# MISSISSIPPI RIVER DAVENPORT, IOWA

### GENERAL DESIGN MEMORANDUM LOCAL FLOOD PROTECTION

VOLUME 1 OF 2  
(REVISED)

SUBJECT: Mississippi River, Davenport, Iowa, Local Flood Protection - Phase II,  
General Design Memorandum (Revised)

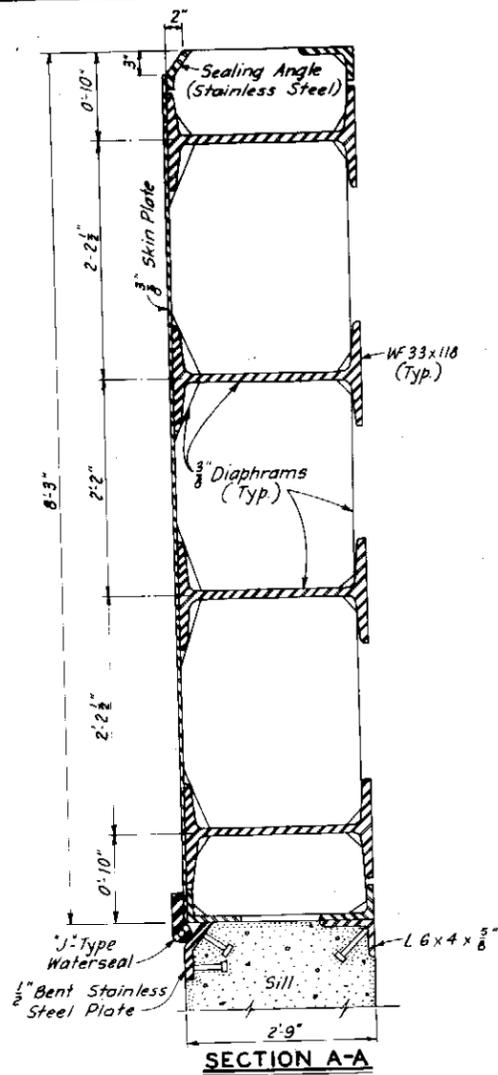
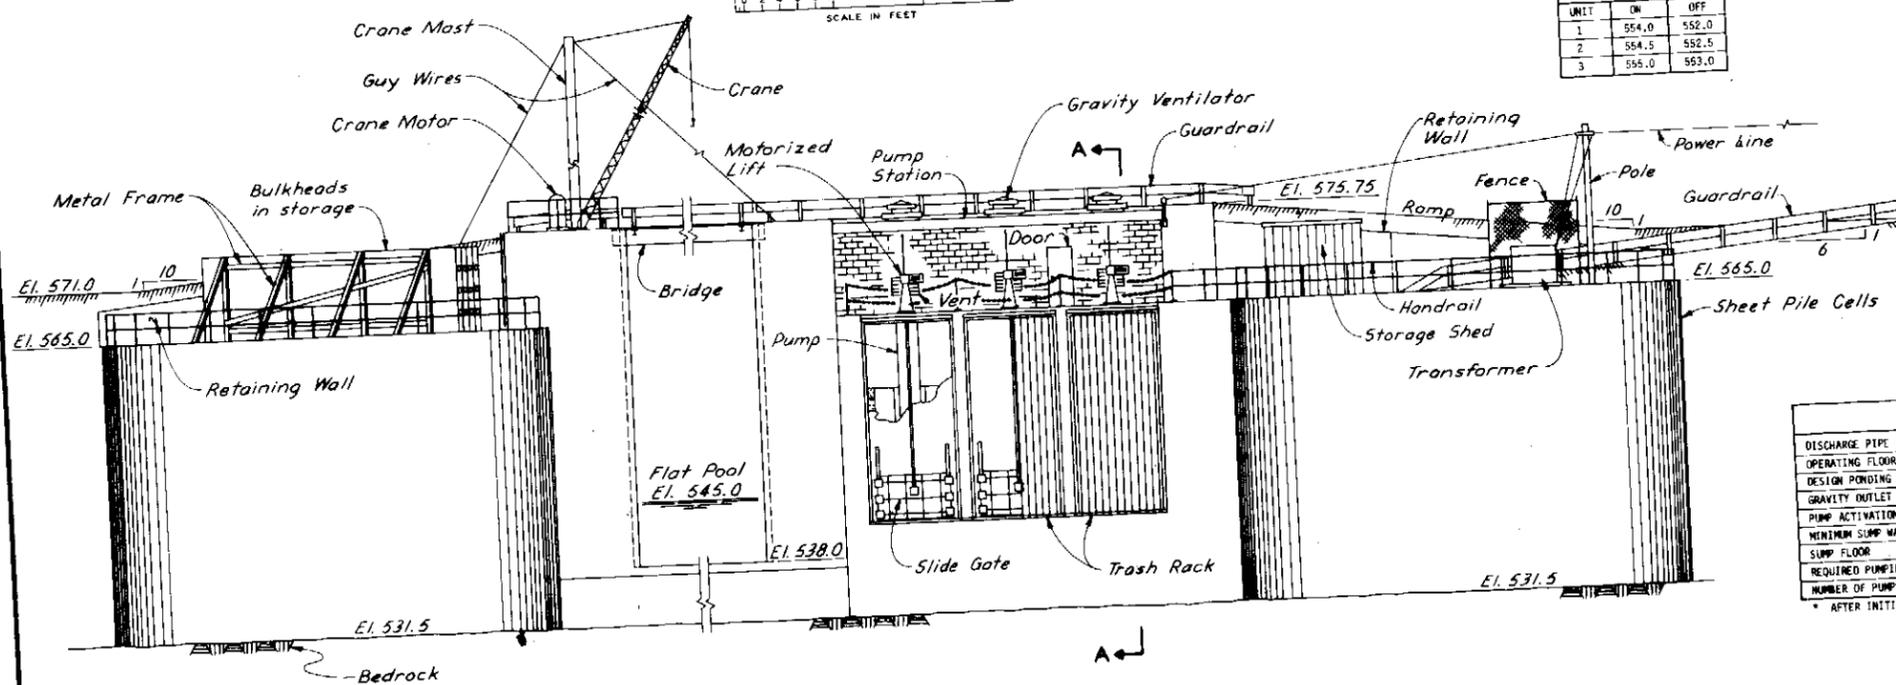
c. Overtopping impacts appear to be minimized in the Credit Island Slough portion of the levee. Consideration should be given to adjusting the freeboard to force initial overtopping in the Credit Island area.

25. The report should indicate if the gate closure elevation for Credit Island Slough impacts on the pump capacity. That is, if the gate closure elevation were set at 553.5 would the selected pump capacity change?
